Docket No. 50-397

Subject: WNP-2 DES REQUEST FOR ADDITIONAL INFORMATION

HYDROLOGIC ENGINEERING GENERIC QUESTIONS

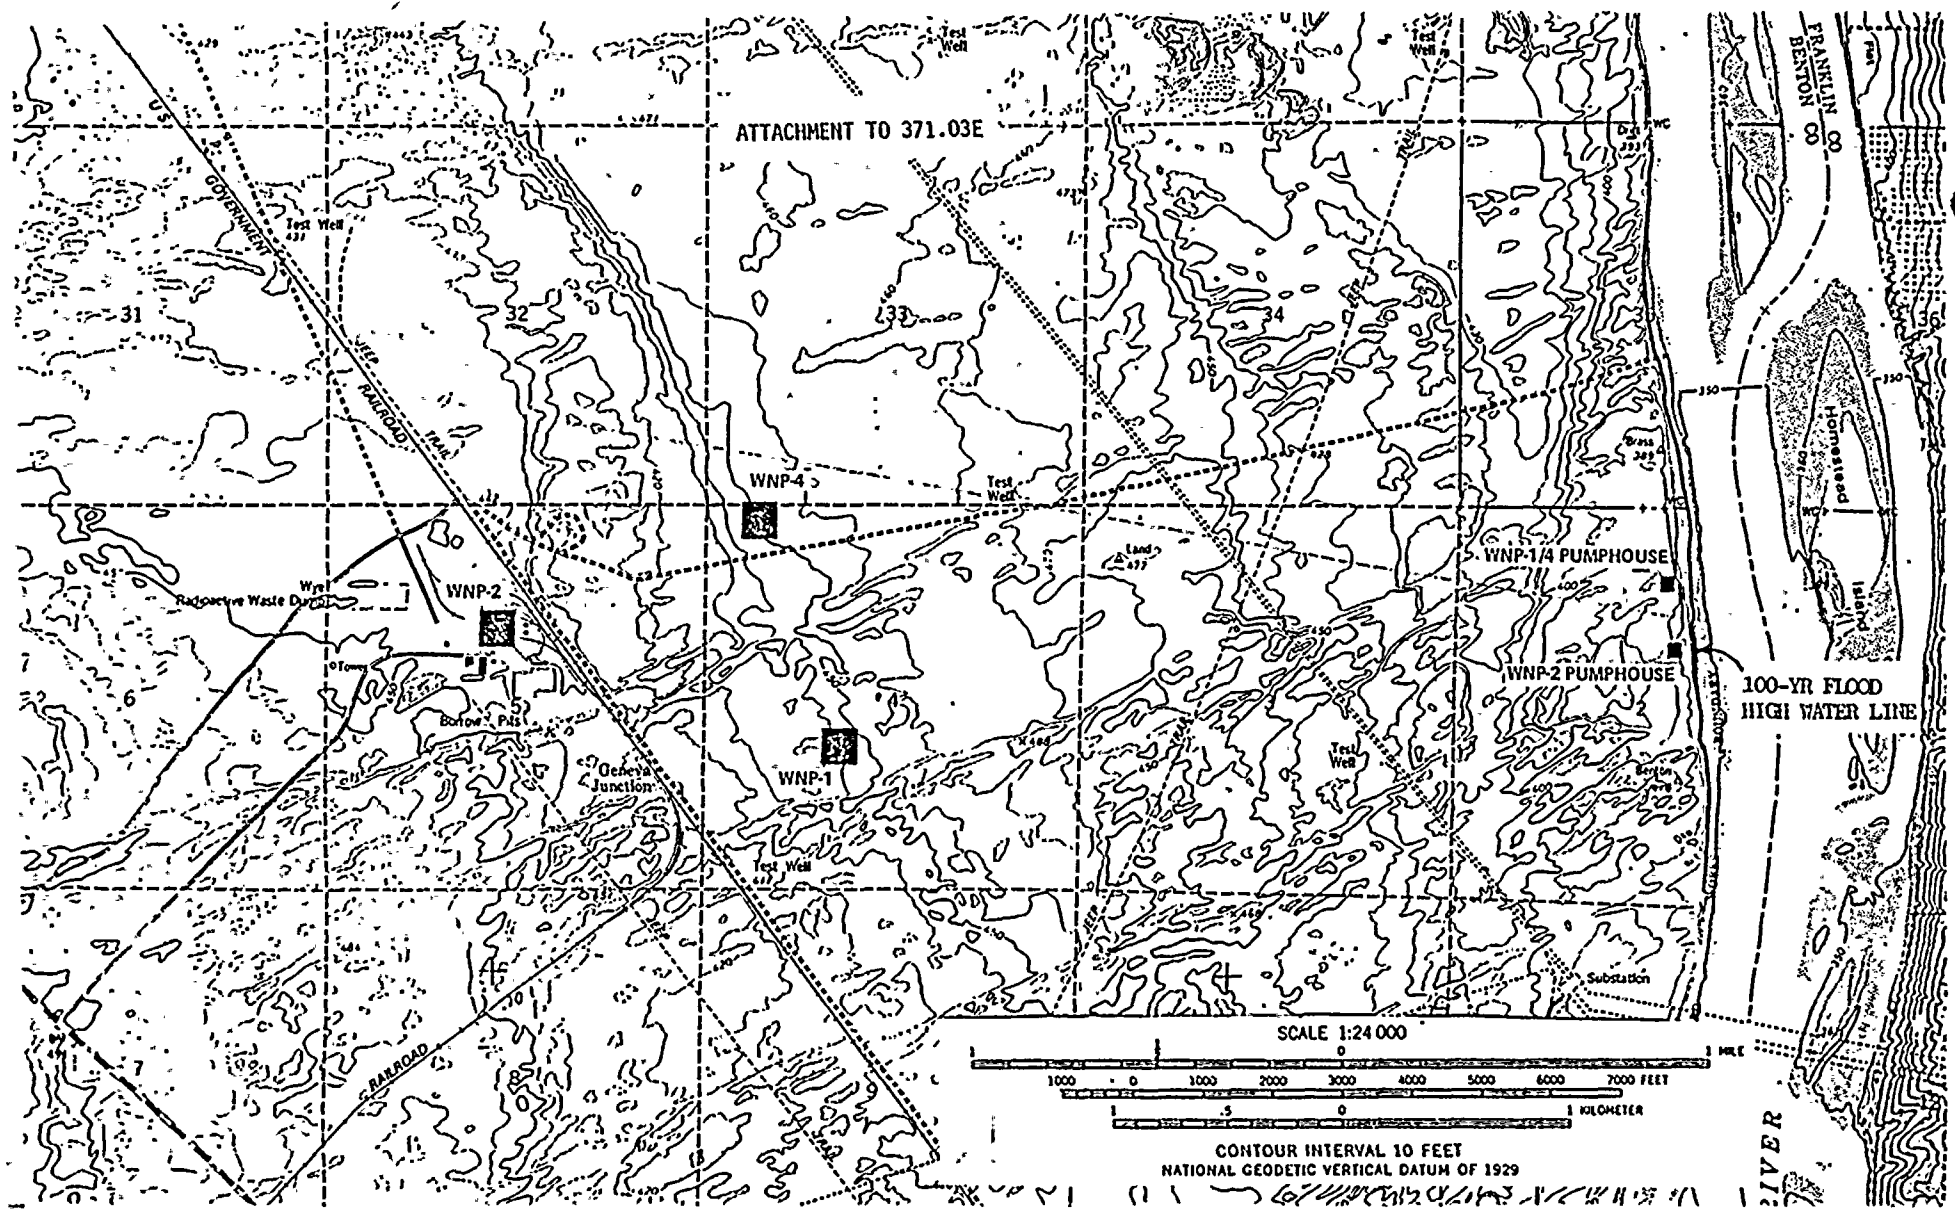
- 371.03E Provide descriptions of the floodplains of all water bodies, including intermittent water courses; within or adjacent to the site. On a suitable scale map provide delineations of those areas that will be flooded during the one-percent chance flood in the absence of plant effects (i.e., pre-construction floodplain).

- 371.05E Identify, locate on a map, and describe all structures and topographic alterations in the floodplains.

The attached figure indicates a natural depression or basin-like area just east of WNP-2. Subsection 2.4.3 of the FSAR includes an evaluation of the flooding in this area from a hypothetical probable maximum precipitation (PMP) event over a 33-square mile "drainage basin". This PMP (determined by FSAR Ref. 2.4-4) has a 6-hour rainfall of 9.2 inches with a peak hour of 5.2 inches. The runoff analysis assumed conservative soil, cover, and antecedent moisture conditions and took no credit for sub-basin storage. The resulting flood levels, calculated for the purpose of a safety evaluation, are based on greatly exaggerated runoff from an extremely conservative rainfall. In fact, this area between WNP-2 and WNP-4 is not an intermittent water course; there is no obvious physical evidence (e.g., surface drainage patterns) that the area has carried or ponded water. Available data indicates that the one-percent 1-hour and 6-hour rainfalls for the Hanford Site are 0.8 and 1.6 inches, respectively (ER-OL Ref. 2.3.1). When the numerous natural depressions and infiltration losses (approximately 2 inches/hour) for the sandy Hanford soils are considered, it is obvious that the 100-year rainfall cannot result in predictable runoff. Accordingly, this low area adjacent to WNP-2 is not a floodplain and is not indicated as such on the attached figure.

The only structures related to WNP-2 which are located in a floodplain are the makeup water intake pipes and cooling water blowdown outfall, which were installed in 1975. These structures, located on the bed of the Columbia River at River Mile 351.7, are depicted by ER-OL Fig. 3.4-7 and 3.4-10.
